Oak Consulting Group

Project 12013

RE: Response to Peer Review Comments  
Village at Bailey's Pond  
Amesbury, Massachusetts

This letter responds to the peer review comments of Gillian T. Davies of the BSC Group as set forth in her letter dated January 29, 2013. In addition to this letter, please find the enclosed:

SHEET: **C-013C**

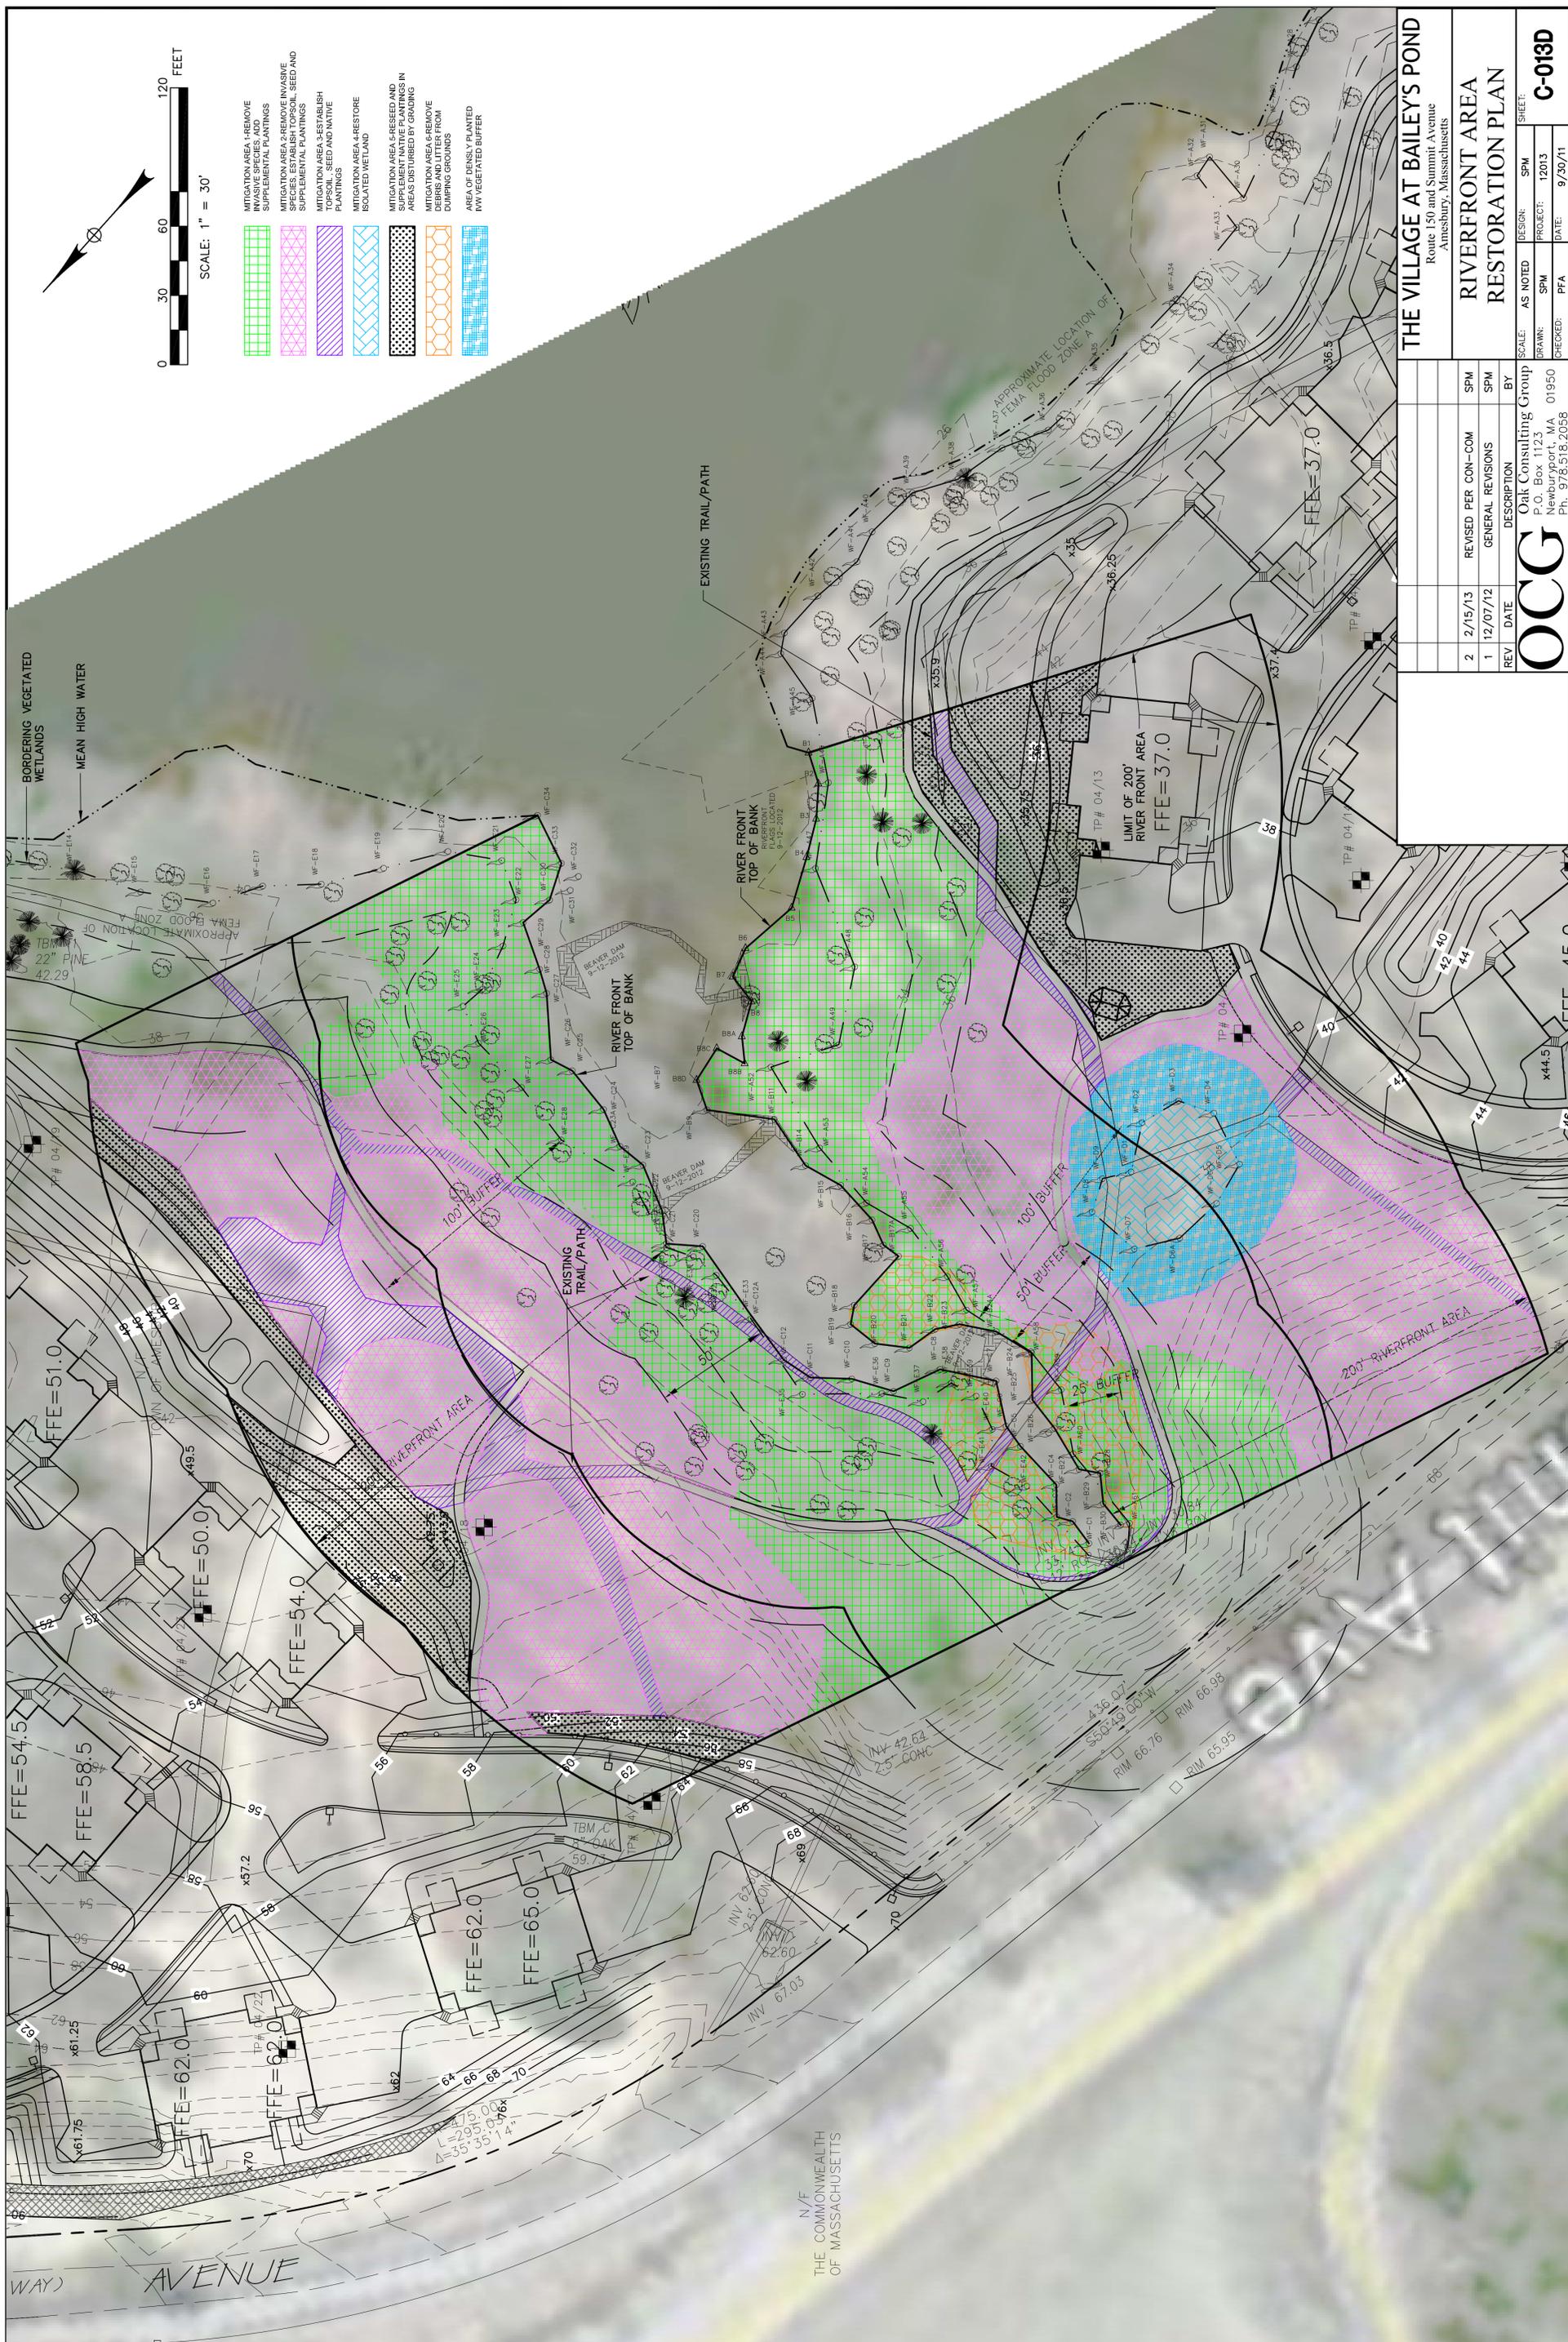
Area 1- This area, shown on plan sheet C-13C in green, is essentially original RA that was not stripped during mining operations. This area functions to a high degree, with some compromised functioning as a result of invasive species, such as buckthorn, bittersweet, honeysuckle, and multiflora rose and discarded household items. The intact topsoil layer has allowed native plants to thrive, and the area provides significant function with regards to food and shelter for wildlife, water quality through filtering of organic chemicals and heavy metals in the rich organic topsoil. In this area, we have proposed to remove the invasive plants and clean up the debris.

Area 2 – This area, shown on plan sheet C-13C in orange, was stripped of topsoil during mining operations but currently supports vegetation. While the area supports some vegetation, the area’s functions are limited (“degraded”) by the absence of topsoil, the limited biodiversity of the plants (due in part to the absence of topsoil), including large areas of invasive plants – Autumn Olive among other invasive species also present within Area 1. The native plants present are generally pioneering species capable of surviving in a soil that lacks the nutrient and organic-rich soil commonly referred to as topsoil. The allelopathic properties of Autumn Olive and some of the other invasive plants present poison the soil to prevent the growth of native plants. If one were to take the root zone in this area, strip the soil and try to sell it at a landscape supplier as topsoil, it would not pass the straight face test with customers. While there may be slightly more organic content near the surface, it lacks anything near the organic content of topsoil in the native soil that is still present in Area 1.

Area 3 - This area, shown on plan sheet C-13C in red, is an area stripped of topsoil and void of any vegetation since active mining of the site prior to 1996. That this area is degraded cannot be genuinely debated. This area covers more than 15,000 square feet of the riverfront area (a larger percentage of the RA than was present in the Ipswich matter referenced above). As discussed above, BSC's view appears to be that this area is not degraded because it is not functioning in a manner similar to pavement. That view is based on a misunderstanding of the regulations. As discussed above, "absence of topsoil" is sufficient to render an area degraded. In the Decision and Order on Motions to Strike and for Directed Decision, In the Matter of Edward T. McLaughlin, Trustee, ETM Realty Trust, the Magistrate addressed this issue...

UTILITY CROSSING PLAN VIEW  
1"=10'

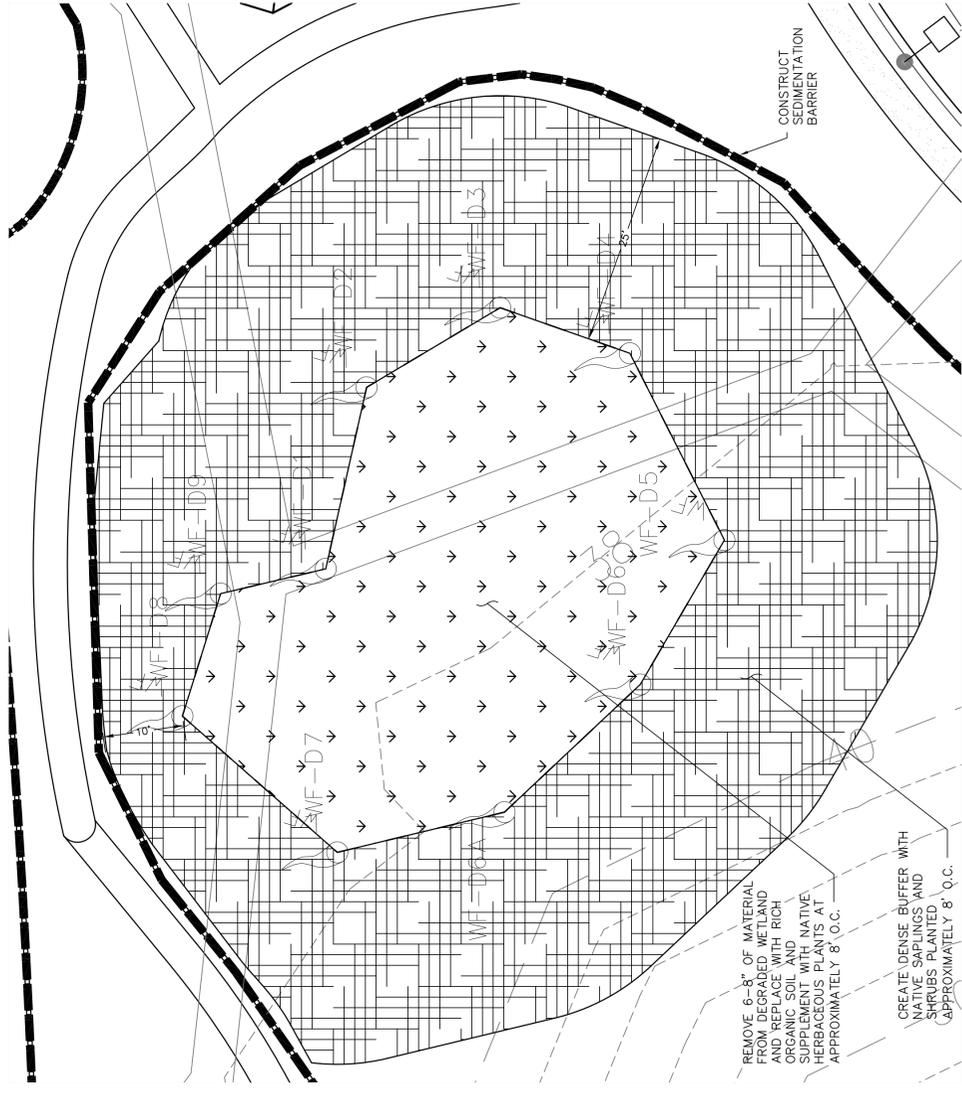
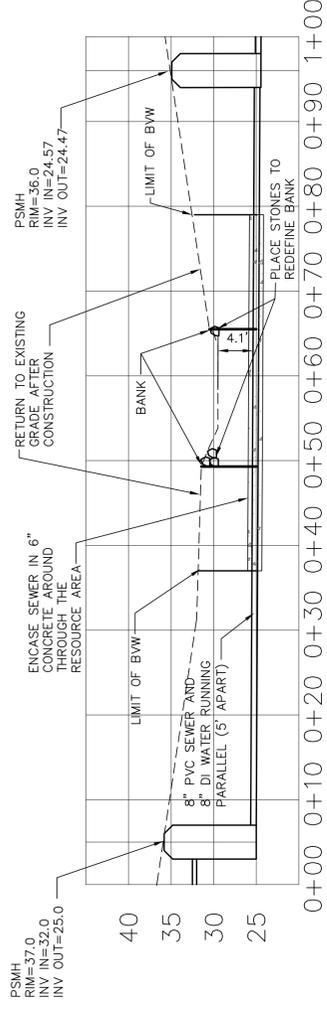
8. *Proposed Stream Crossing:* Any proposal for a stream crossing, such as the proposed sewer crossing, should include detailed plans & cross-sections (existing conditions, proposed conditions, and eventually, as-built conditions), and text (some of which has been provided) describing the construction sequence, erosion and sedimentation controls, bank stabilization measures, and resource (Land Under Water, Bank, BVW) restoration plans, as well as text (some of which has been provided) regarding compliance with resource area performance standards at both the state and local level. This work has been described in general terms only. The Applicant has proposed Bank restoration that exceeds replacement of the currently ATV-impacted Bank conditions. The details of this Bank restoration work should be provided, both in visual (plans & cross-sections) and in text form, for any Alternative (and some Alternatives may not require a stream crossing) that includes a stream crossing. BSC concurs with the Applicant that the portion of current BVW that is actually ATV-impacted previous Bank, should be restored to Bank, rather than to BVW.

**RESPONSE:** Stream crossing details have been provided on Sheet C-014, submitted with this letter.
